To: Design Review Board
From: Scott Guter, Planner
Date: March 13, 2017
File No.: DRV17-00073
Subject: **EASTSIDE PREPARATORY SCHOOL EXPANSION – FINE ARTS BUILDING DESIGN RESPONSE CONFERENCE**

**EASTSIDE PREP- TALI HALL
DESIGN REVIEW
DRV17-00073**

TALI HALL
Classroom and Arts Building

HEIGHT CALCULATION
[AVERAGE BUILDING ELEVATION DIAGRAM]

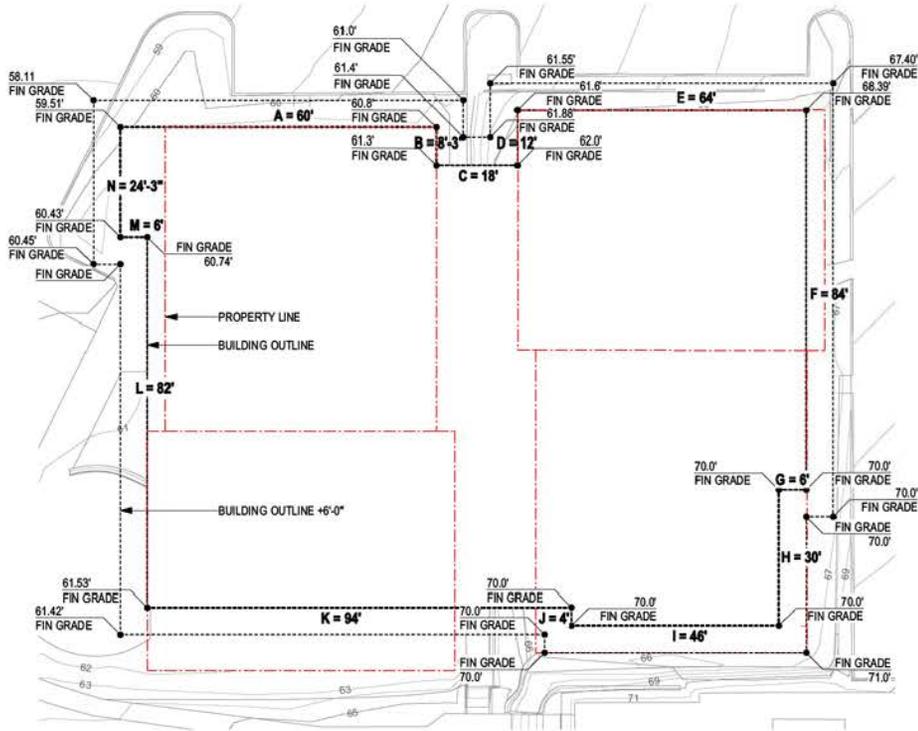
Staff Comment: Preliminary height calculations show that the proposed building is at the maximum height allowed. With the building permit application, the applicant should provide the height calculation site plan as a layer atop the survey information so that staff can confirm the topography and midpoint segments used. Staff's final review of the height calculation will occur with the building permit review.

LOT COVERAGE CALCULATION

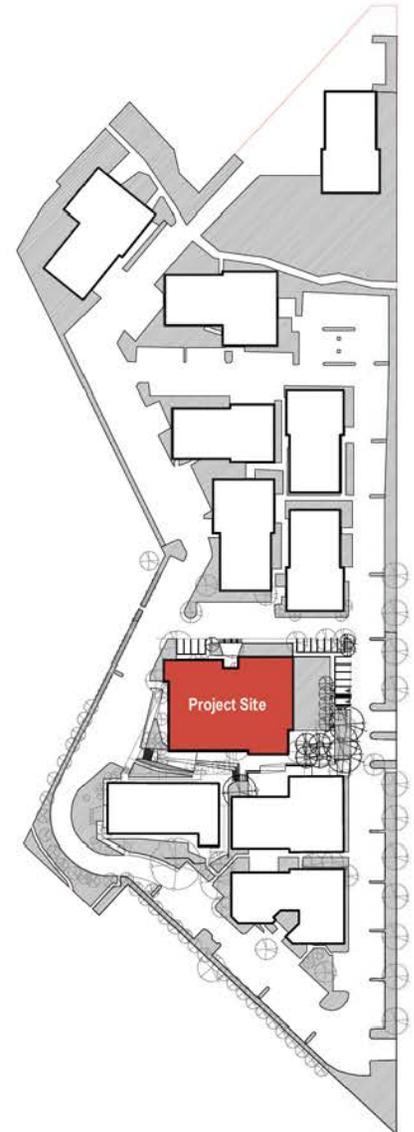
Staff Comment: Preliminary lot coverage calculations show that with the proposed changes, the entire Linbrook campus is at approximately 72% lot coverage. The applicant should submit final lot coverage information with the building permit application. Lot coverage information needs to include the entire Linbrook campus. Staff's final review of the lot coverage calculation will occur with the building permit review.

LANDSCAPE PLAN

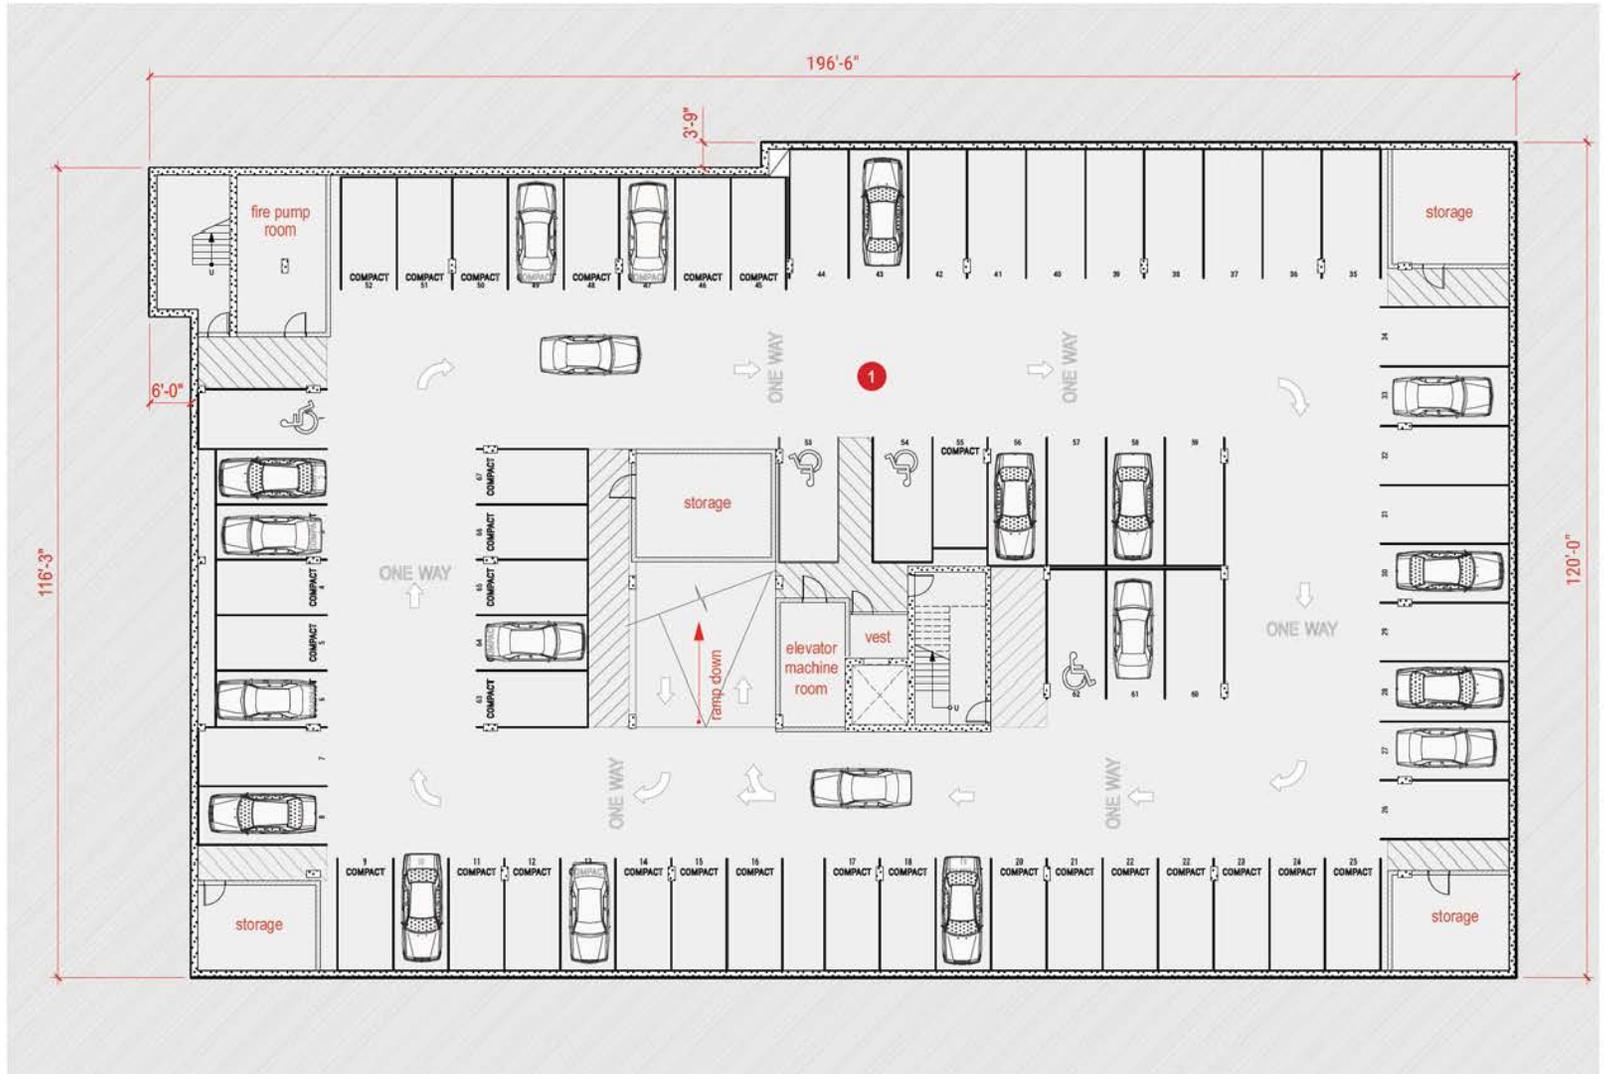
- a. DRB Discussion. The DRB requested a detailed landscape plan. The applicant should continue to explore additional landscaping opportunities along the north façade of the proposed building. The applicant should also include a description of how open space areas will be used.

- What changes if any are needed to the landscape plan?
- Are there other opportunities for landscaping?

[PUBLIC47: Provided in the landscape plan. See packet for planting schedule and images of appropriate plants and trees.]

MATERIAL PALETTE

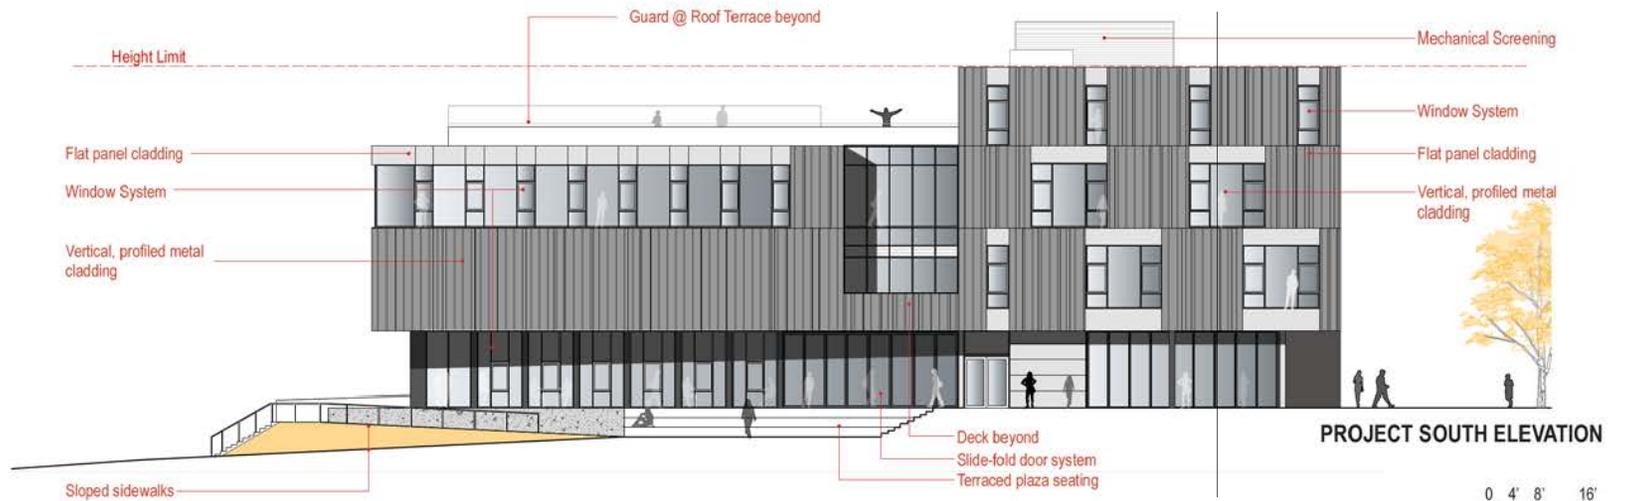
- *Avoid use of concrete block and large expansive tilt up concrete facades.*
- c. Staff Analysis. Attachment 4, pages 23-25 contain color elevation drawings and callouts for the proposed building materials. The DRB should provide feedback to the applicant regarding the proposed materials and colors. The DRB should discuss whether samples of materials and colors should be provide at the next Design Response Conference.
